UNITED STATES PATENT AND TRADEMARK OFFICE

APPLICATION NO.	FILING DATE	FIRST NAMED INVENTOR	ATTORNEY DOCKET NO.	CONFIRMATION NO.
09/811,554	03/20/2001	Houng Joong Kim	503.39902X00	3907

Office Action Summary

DETAILED ACTION

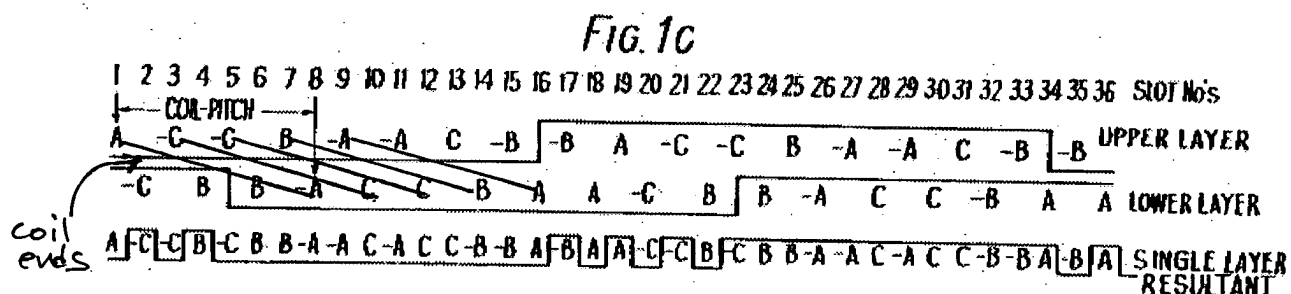
10. Applicant's arguments filed October 15, 2002 have been fully considered but they are not persuasive. Applicant argues that Broadway teaches a winding arrangement similar to that shown in applicant's prior art Fig.10(b), where there is only one phase in each peripheral layer. However, the embodiment of Fig.1C of Broadway shows an arrangement of a three-phase, single layer winding in which the single layer comprises windings of all three phases A-C and which are further arranged so as to satisfy applicant's claimed relationship. Note that the coil pitch is 7, meaning that, for example, the phase coil section A in the "upper" layer in slot 1 travels to the "lower" layer coil (-A) in slot 8. Similarly, coil -C in the upper layer of slot 3 travels to the lower layer of slot 10 (C), and so forth. The end turns connecting the coil sections A/A-, -C/C, -C/C, B/-B, etc. are parallel with one another, slanted at an angle. See Broadway's Fig.1C below.

Fig. 1c

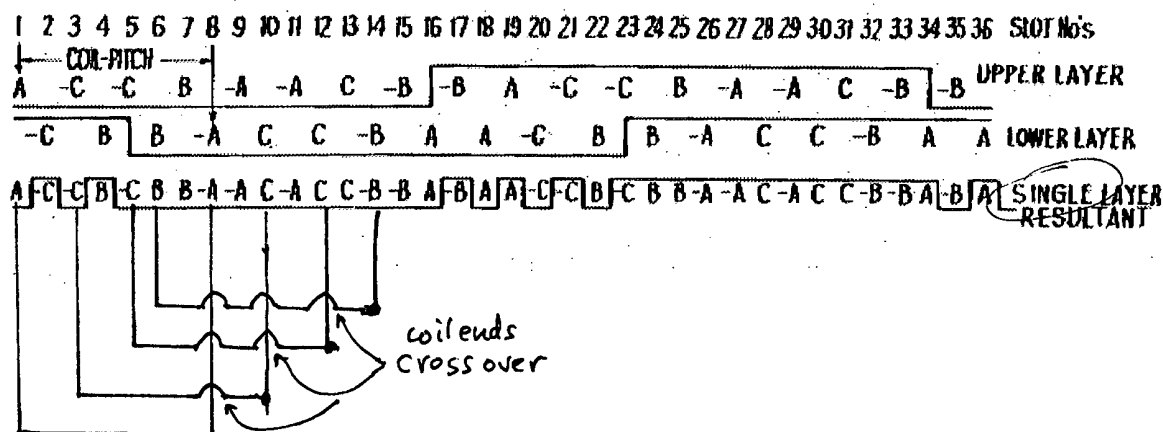
If the coils were arranged as shown in applicant's Fig.10(b), as applicant asserts, each coil end would have to cross over another at some point, when viewed along the axial direction; however, this would result in a multi-layer winding. See the modified Fig.1C of Broadway below. Broadway specifically states that the winding is single layer. Therefore, the Broadway windings do not overlap as applicant suggests.
